TI EVM Boad Evaluation

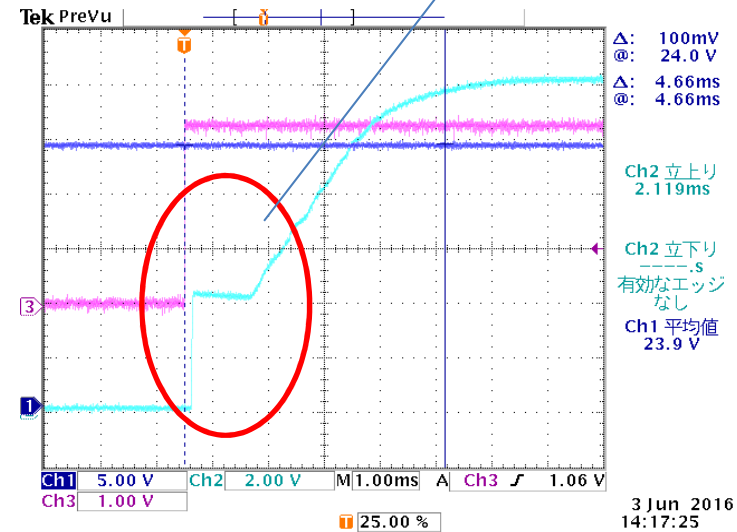
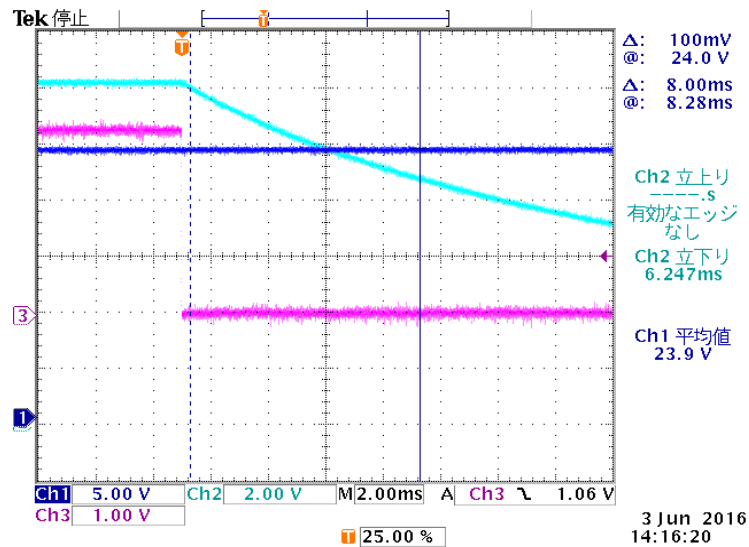
It's like stairs.

It's a question.

En pin : When it's shorter than 2 seconds.

Why will output be like stairs?

Ch1 : Input voltage
24V(VCC-MAIN)
Ch2 : output voltage
5V

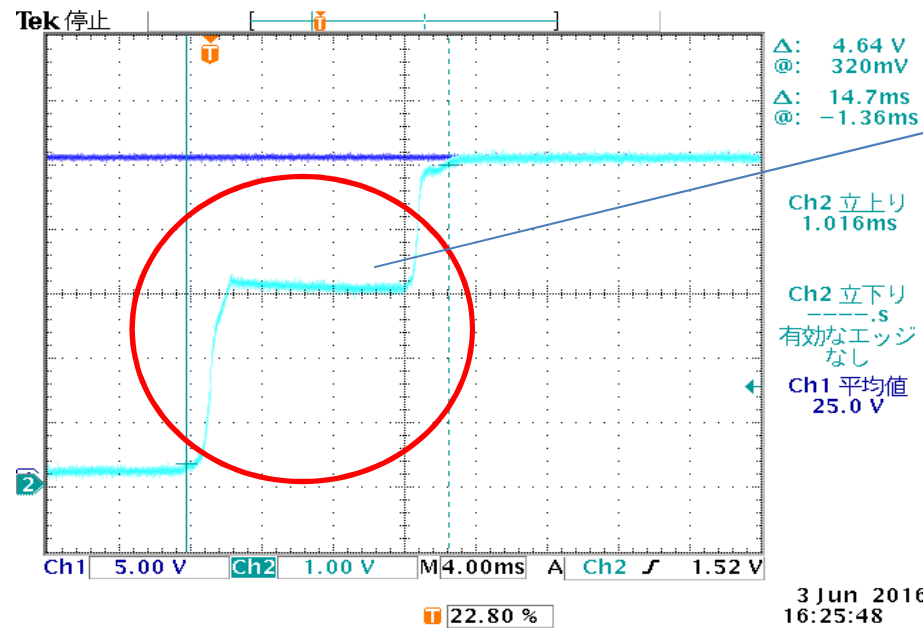
It's like stairs.
